RESIDENTIAL BUILDING PERMIT APPLICATION
 HOWARD COUNTY DEPARTMENT OF INSPECTIONS, LICENSES, AND PERMITS
 3430 COURT HOUSE DRIVE, ELLICOTT CITY, MD 21043 - PHONE: (410) 313-2455 OPTION #4
 www.howardcountymd.gov

Street Address: 13845 MILL CREEK CT Unit:
 City: CLARKSVILLE State: MD Zip Code: 21029
 Subdivision/Village/Complex Name: MILL CREEK SDP/WP/BA #:
 Lot: 19 Tax Map: Parcel: Grading Permit #:

I have reviewed your building permit for 13845 Mill Creek Court and your proposed plan must be revised. Approval for a fence cannot occur because a basket ball court cannot be placed in the septic area and you cannot place a fence in the septic area. The basketball court must be removed or you will be held in violation. Also submit a new plan showing court and fence in a new area located outside of the septic area. If you have any questions don't hesitate to reach out through e-mail.

Hello Kristy everything looks good. However, we have a few minor changes on your OSDS plans. They must be revised and resubmitted for review. Your building permits will not receive building permit approval until the OSDS plans have been approved. I will list them in order of lot.

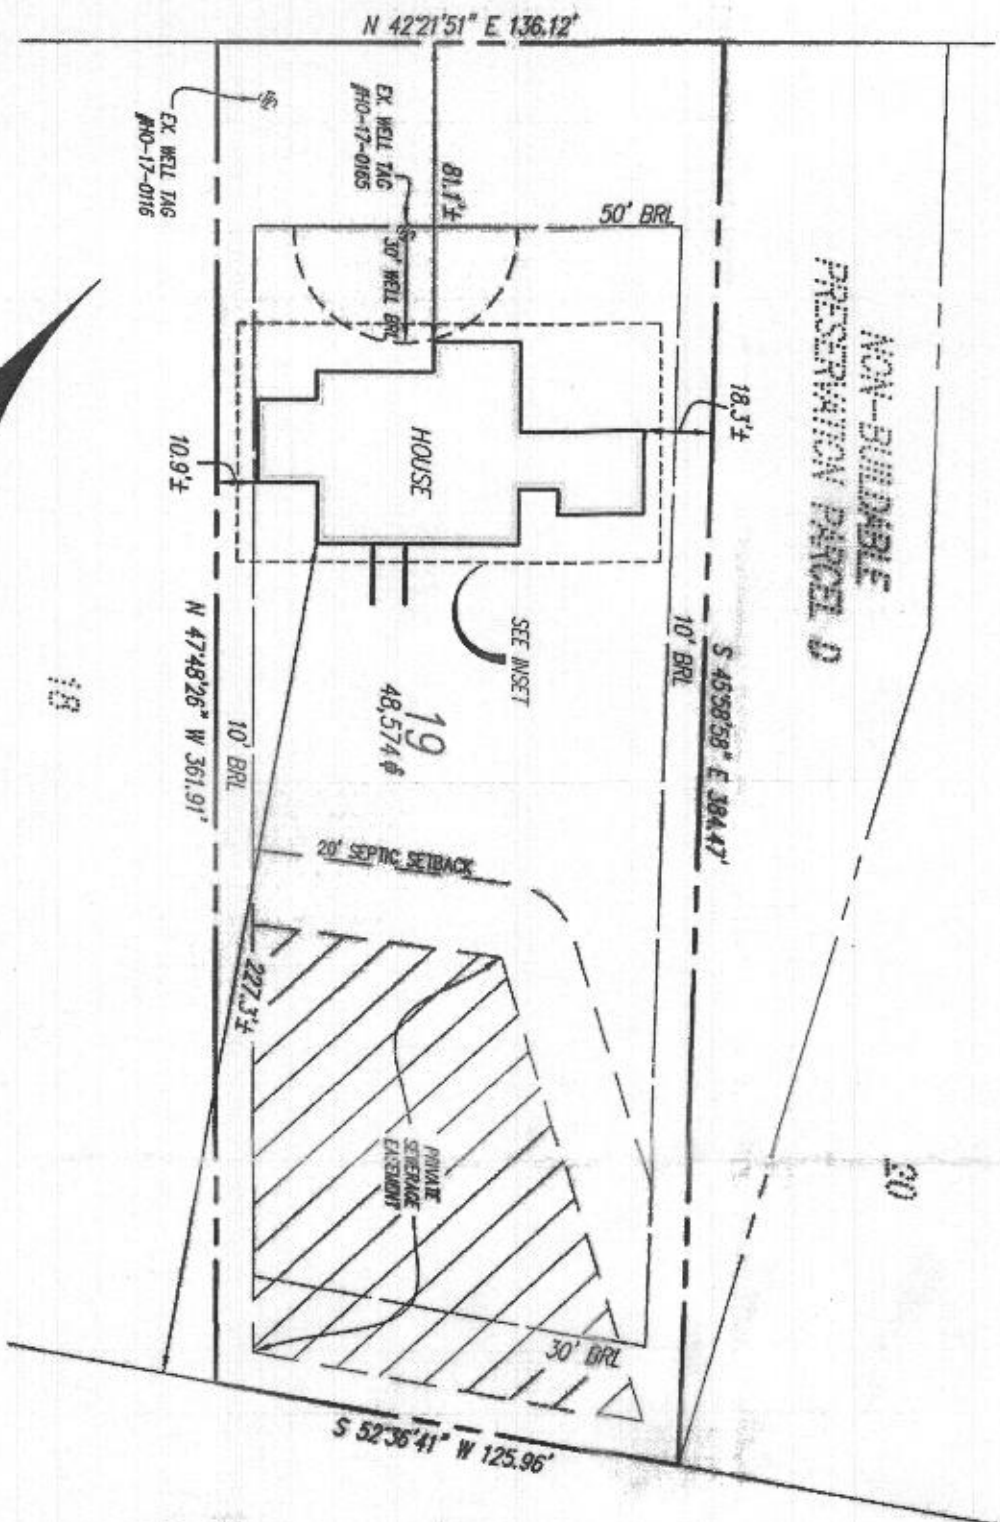
It looks like GLW did the original design plan for the septic system when the house was built. What we are shooting for is to carve out the overlap and stay over 10,000 sq ft. They would need to submit a revised perc certification plan for our approval. They can extend toward the house a bit past test hole 54A, they can go to 5' from the property line on the side and rear, and they can request to go to 5' from the court instead of 10' if needed. They could request to get closer to the court if they need it to get above 10,000 sq ft on the revised area.
